**CAPITAL PROJECTS  
ADDENDUM NUMBER 2  
for  
CLYDE RIVER BRIDGE CROSSING - TCH EXTENSION  
(Scheduled Tender Closing 22 February, 2018)**

**DATE: 9 February, 2018**

**SUBJECT: Schedule A - Errata  
Specifications - Errata  
Drawings - Errata**

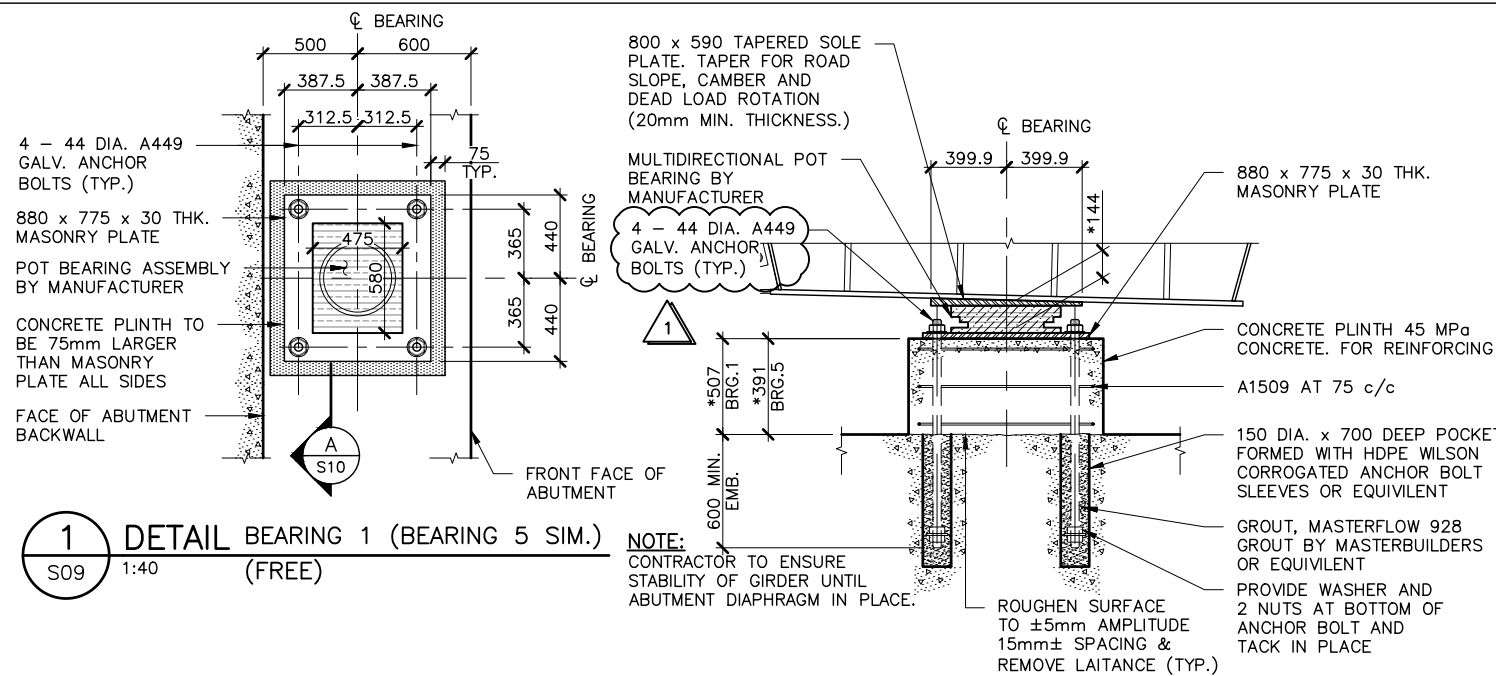
3. Attached is Drawing S03, Rev. 1, General Notes. Please remove the existing Drawing Sheet S03, Rev. 0 and replace it with the attached. The change is required to edit the following under Steel Notes:

- a. Note 1 a) shall read as follows: "WEBS, FLANGE PLATES, STIFFENERS, DIAPHRAGMS TO G40.21 - 350AT CAT 2."
- b. Note 1 c) shall read as follows: "HIGH STRENGTH BOLTS ASTM F3125 GRADE A325 TYPE 1, THREADS TO BE EXCLUDED FROM ALL SHEAR PLANES (U.N.O.)." A325 bolts shall NOT be galvanized.
4. Drawings S06, Detail 1/S04; the Wabo Compression Seal WA-500, by Watson Bowman, shall be considered as an acceptable alternate to the D.S. Brown CA-4500 compression seal.
5. Attached is Drawing S11, Rev. 1, Bearing Details - Sheet No. 2. Please remove the existing Drawing Sheet S11, Rev. 0 and replace it with the attached. The change is required to correct the leader in Sections A, B, C and D to the correct anchor bolt designation.
